ECE/TRANS/WP.29/2010/25
18 December 2009

Proposal for Supplement 11 to the 01 series of amendments to Regulation No. 53
(Installation of lighting on L₃ vehicles)

Submitted by the Working Party on Lighting and Light-Signalling */

EXPLANATION ABOUT "THE HORIZONTAL INCLINATION", "THE BANK ANGLE"
AND THE ANGLE " δ ".

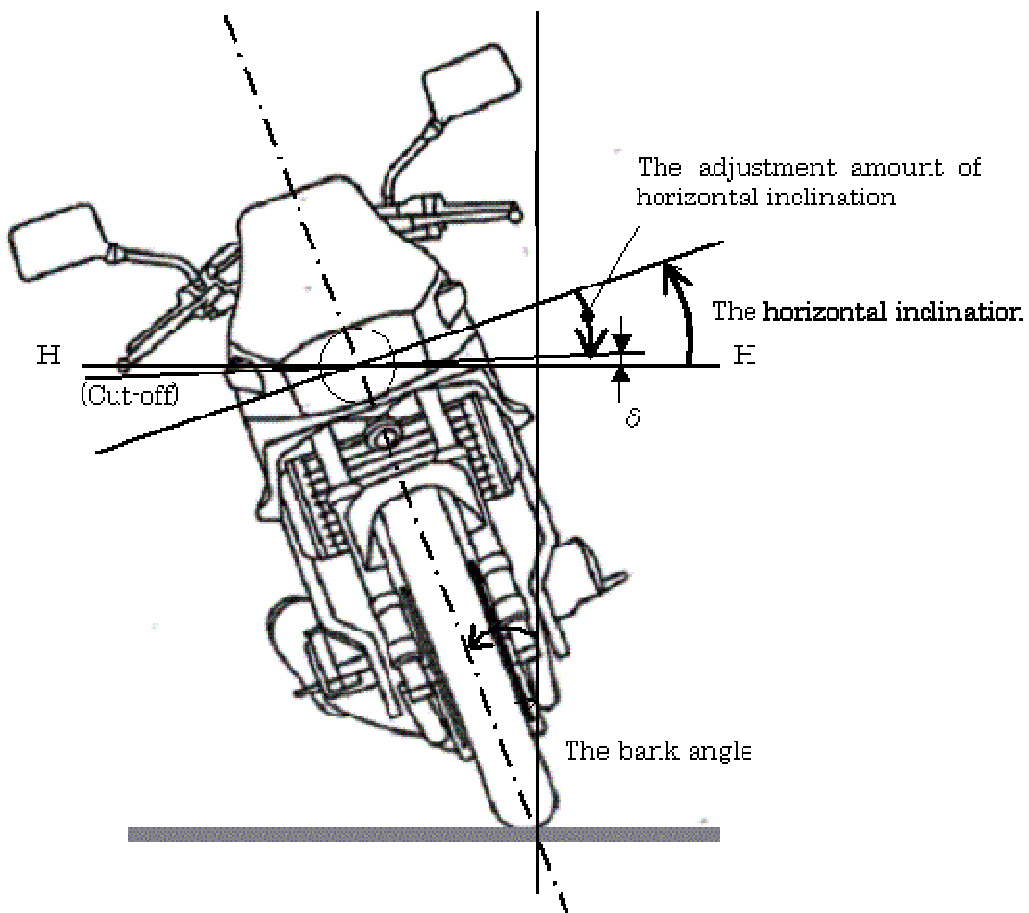
- "2.24. "Horizontal inclination" means the angle created between the beam pattern when the motorcycle is set as specified in paragraph 5.4., and the beam pattern when the motorcycle is banked (see drawing in Annex 6).

- 2.25. "Horizontal inclination adjustment system (HIAS)" means a device that adjusts the horizontal inclination of the headlamp towards zero.
- 2.26. "Bank angle" means: the angle made with the vertical by the vertical longitudinal median plane of the motorcycle, when the motorcycle is rotated about its longitudinal axis (see drawing in Annex 6).

- 2.29. "HIAS test angle" means the angle δ created by the headlamp cut-off line and HH line (in case of an asymmetrical beam headlamp, the horizontal part of the cut-off shall be used), (see drawing in Annex 6)."

Insert a new Annex 6, to read:
